CITY PLAN COMMISSION**THURSDAY, MARCH 23, 2023****FILE NUMBER:** S223-082**CHIEF PLANNER:** Mohammad H. Bordbar**LOCATION:** Maple Avenue, north of McKinney Avenue**DATE FILED:** February 22, 2023**ZONING:** PD 193(HC)**PD LINK:** <https://dallascityhall.com/departments/city-attorney/Articles/PDF/Article%20193.pdf>**CITY COUNCIL DISTRICT:** 14 **SIZE OF REQUEST:** 0.6136-acres **MAPSCO:** 45F**APPLICANT/OWNER:** Pasha & Sina, Inc.

REQUEST: An application to replat a 0.6136-acre tract of land containing all of Lots 7, 8, and 9 in City Block 1/949 and a portion of tract of land in City Block 1/949 to create one lot on property located on Maple Avenue, north of McKinney Avenue.

STAFF RECOMMENDATION: The request complies with the requirements of PD 193 (HC); therefore, staff recommends approval of the request subject to compliance with the following conditions:

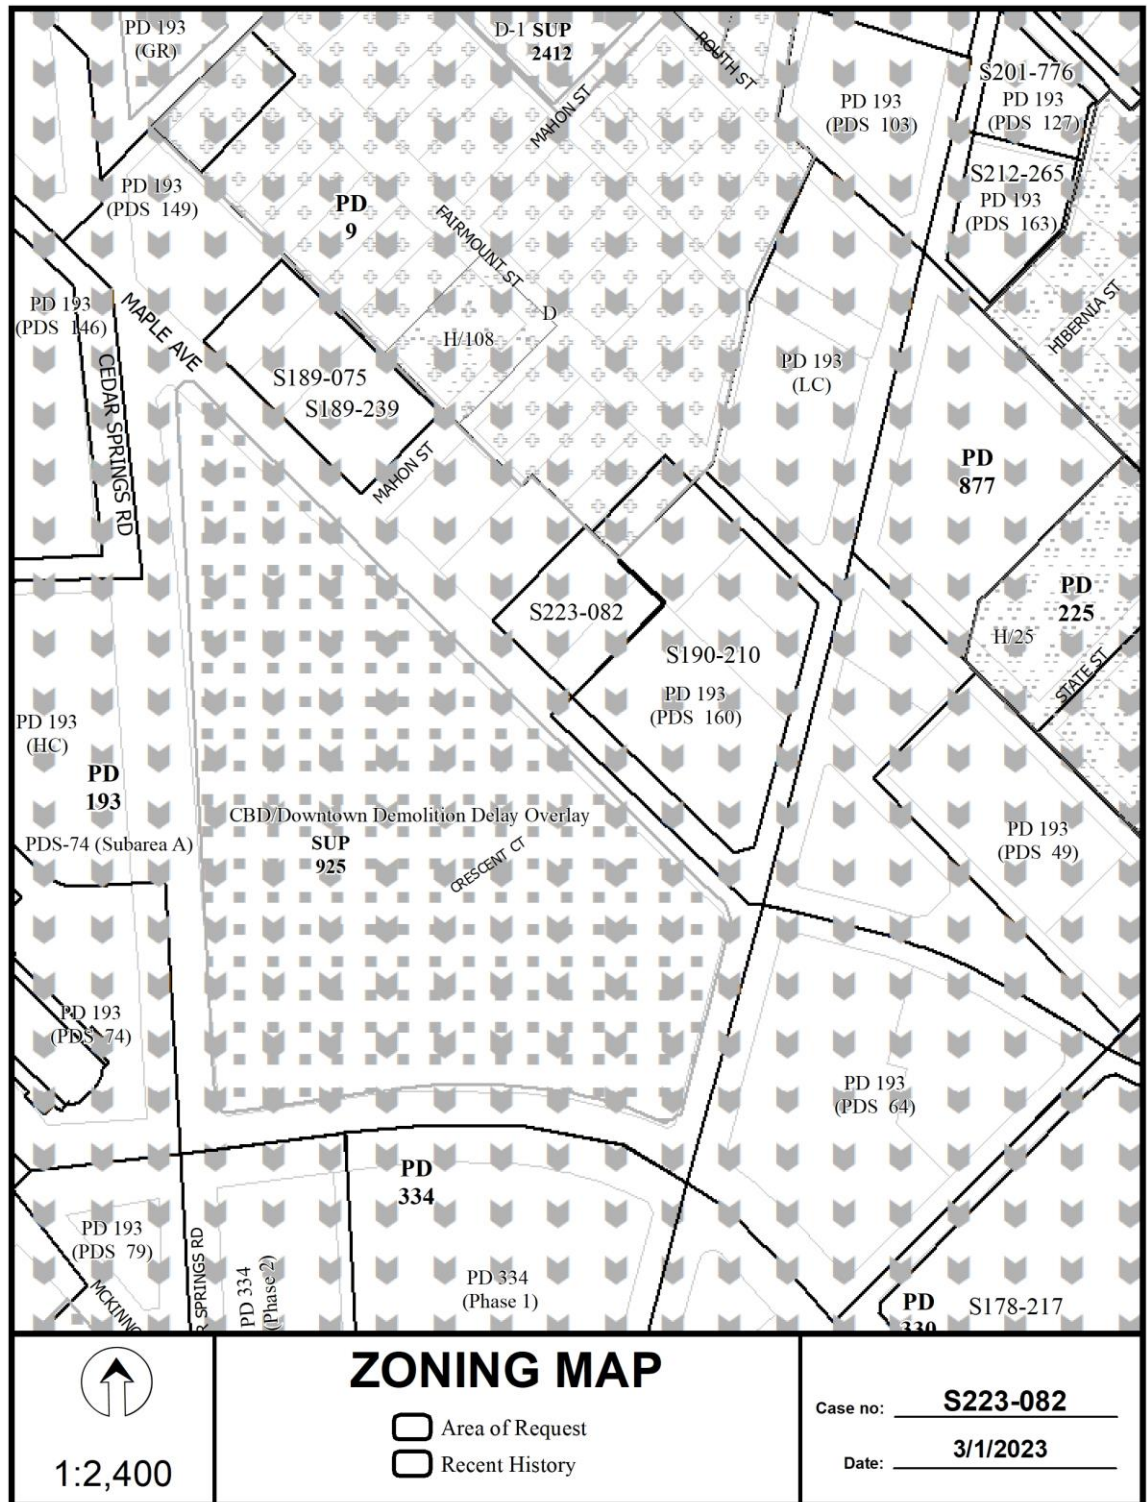
22. On the final plat, change "Mahon Street (Formerly Grace)" to "Mahon Street (F.K.A. Marlin Street)". Section 51A-8.403(a)(1)(A)(xii)
23. On the final plat, change "Fairmount Street (Formerly Peak Street)" to "Fairmount Street (F.K.A. Peak Street)". Section 51A-8.403(a)(1)(A)(xii)
24. On the final plat, identify the property as Lot 7A in City Block 1/949. Ordinance 1A, Page 131 pages 131-148, Section 2 (passed August 13, 1872).
